PIC18F2420/2520/4420/4520

PIC18F2420/2520/4420/4520 Data Sheet Errata

Clarifications/Corrections to the Data Sheet:

FIGURE 6-3: TABLE POINTER BOUNDARIES BASED ON OPERATION

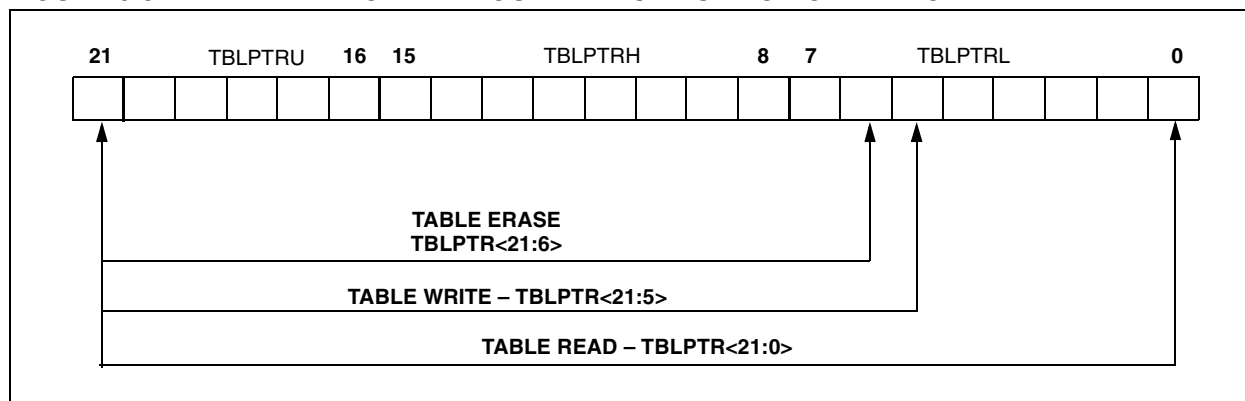
4. Module: Figure 6-3: Table Pointer Boundaries Based on Operation

Figure 6-3 has been replaced with the following figure:
